Service Kit no.: SK-429EC-600-2

Title: Bell 429 Instrument Panel duct upgrade installation

Purpose: To provide instructions for the installation of a modification to the cockpit air conditioner outlets. This modification to the 429 factory cockpit air duct design is intended to redirect conditioned air to the upper body of the crew. The existing outboard outlets located by the door pillars are replaced by outlets located on the sides of the instrument panel glare shield.

Figure 1. Removal of existing ductwork

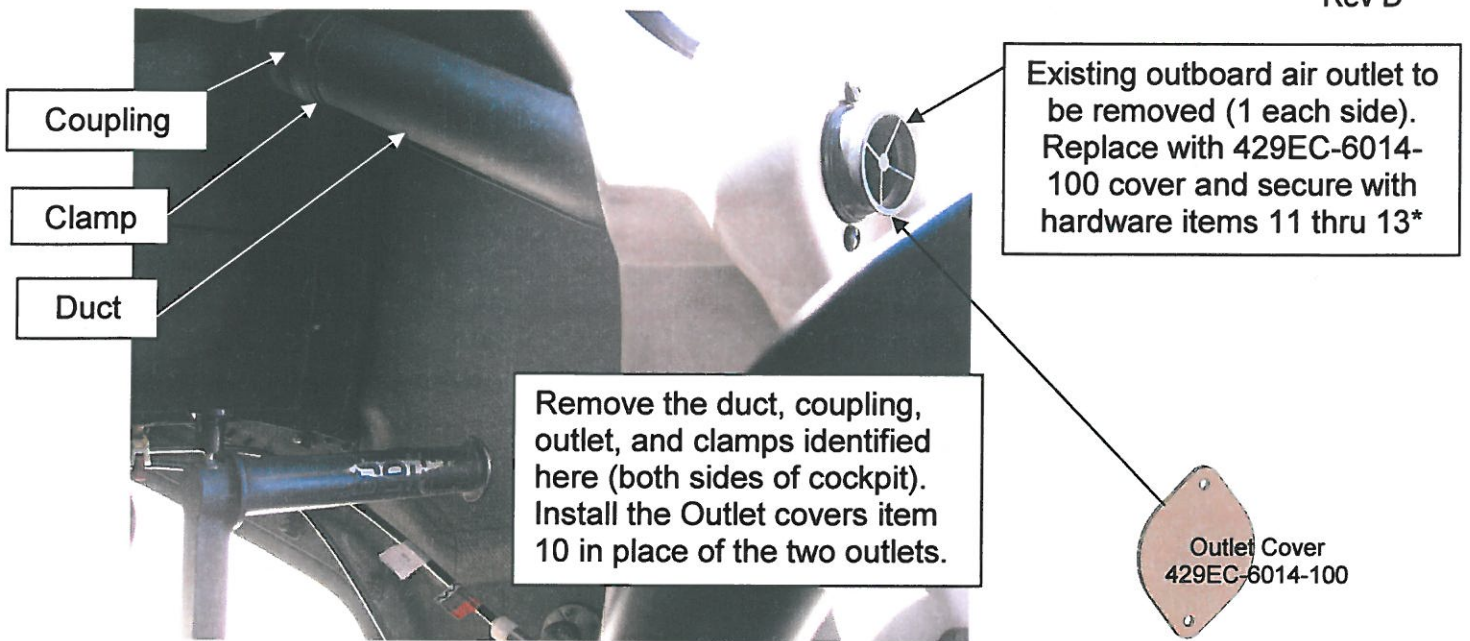
- 1) Remove the existing outboard air outlet located by the door pillar (1 each side) per figure 1.*
- 2) Remove and set aside existing map holder (figure 3). Discard the existing hardware.
- 3) Attach items 1,7,8,9, and the map holder to the right side of the instrument panel shroud using the hardware provided.
- 4) Install items 3,4,6 as shown in Figure 3. Secure duct joints with clamps item 5.
- 5) Repeat above steps for the left side.

Figure 4. Duct cut detail for p/n 429-025-342-102
(applicable only for Aircraft serial no.s 57081 thru 57250)

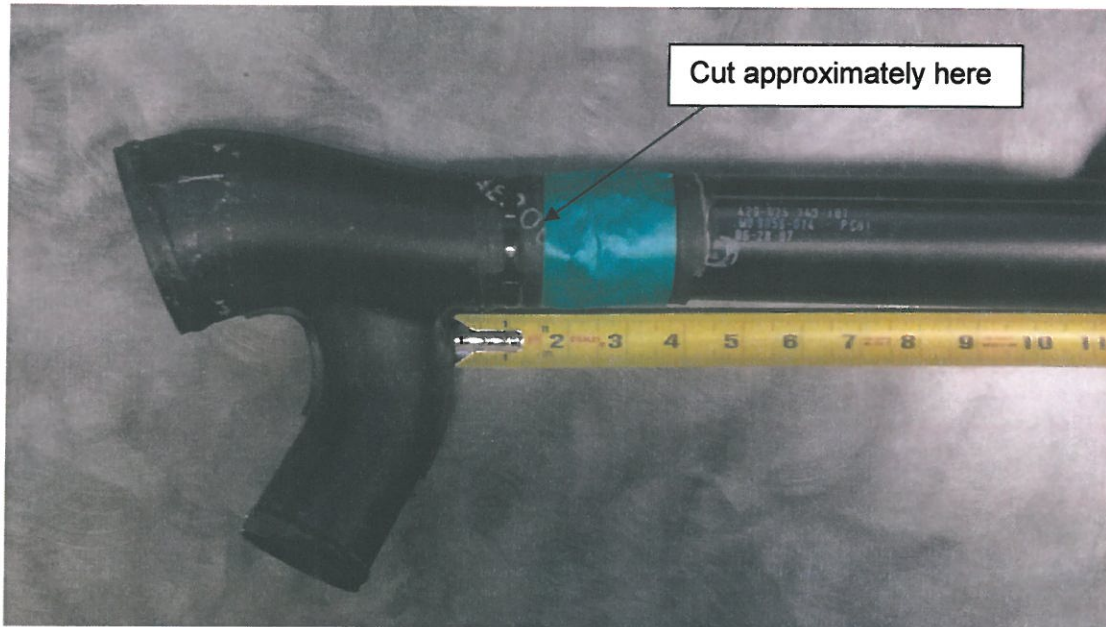
*NOTE: Aircraft serial no.s 57081 thru 57250 are fitted with an air outlet duct that's configured with an integral Y fitting in place of the coupling and clamp shown in Figure 1. It is permissible to alter this duct by cutting through the duct approximately 1.5-2.0 inches aft (See Figure 4) of the Y branch and remove the aft portion duct / air outlet assembly. Alternately the integral duct/Y p/n 429-025-342-102 can be replaced by the short Y fitting p/n 429-025-142-102 right side, p/n 429-025-142-101 left side.
